# Application Note No. AP 2010/21-1

## Topic: Modified connection rules for terminal X20 on the KES module

Picture name: ZCH\_KEKW\_KES\_Hauptschuetz.ai

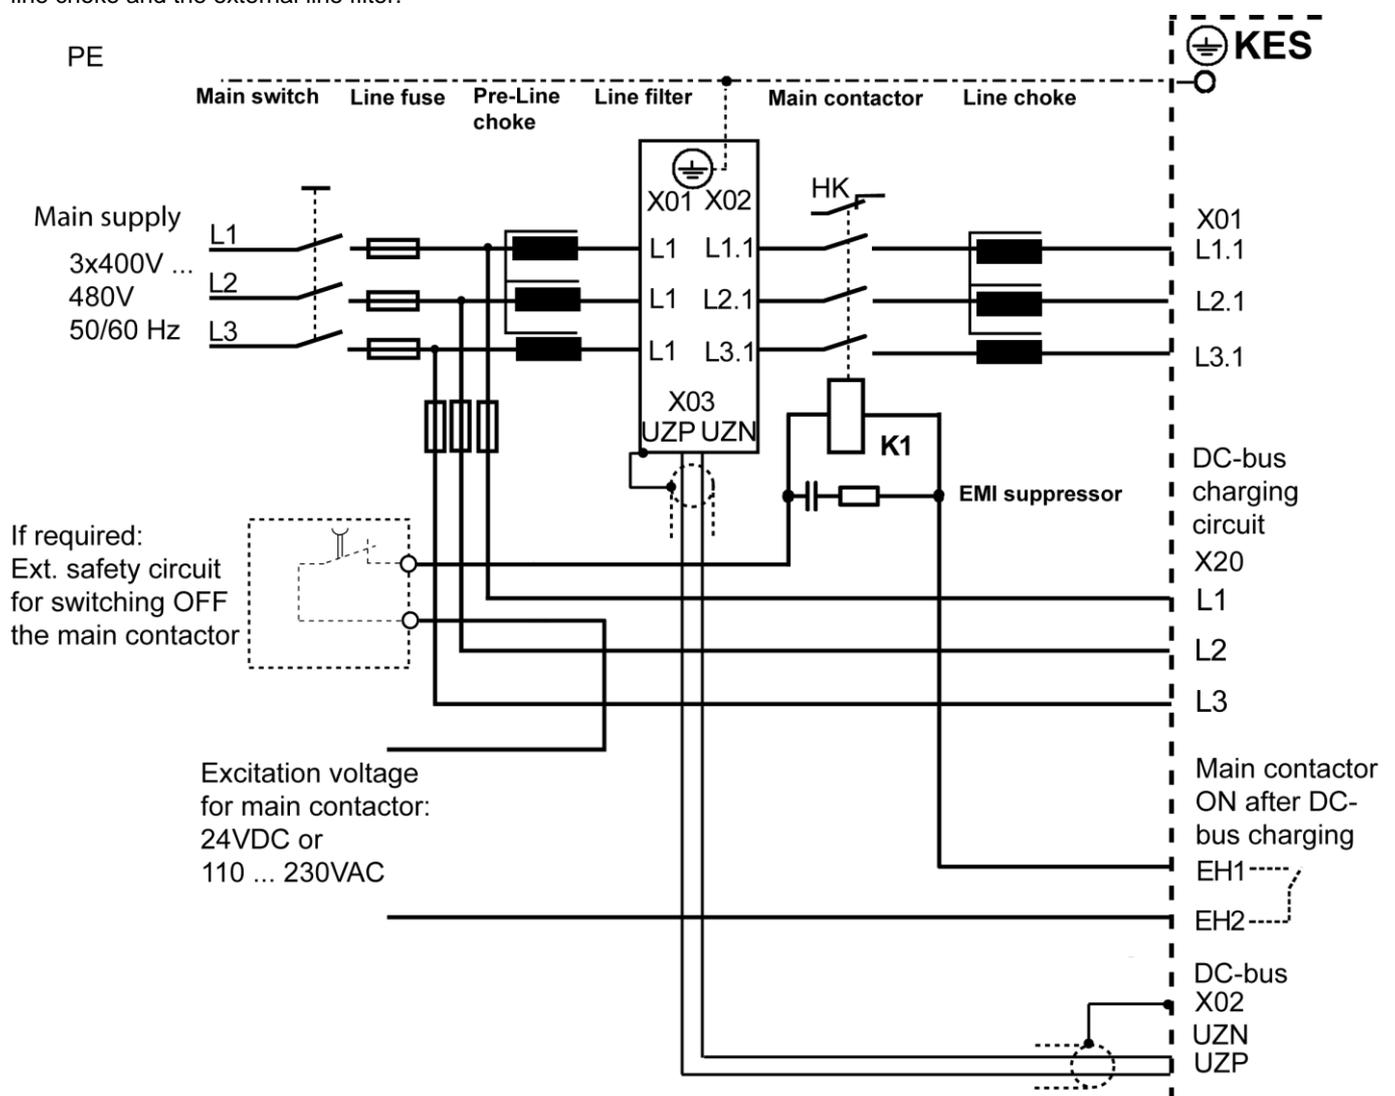
The KES system behaviour at occurring mains irregularities is improved at the KES firmware V3.03 2010/18 due to a changed wiring rule and the optimised mains-voltage monitoring and feed forward.

The terminal X20 on the KES module is to connect between the mains and the pre-line choke beginning from firmware .V3.03 2010/18 (AMK-part-no.: 203000). At older versions (before V3.03 2010/18) the terminal X20 is to connect as before between the line choke and the external line filter.
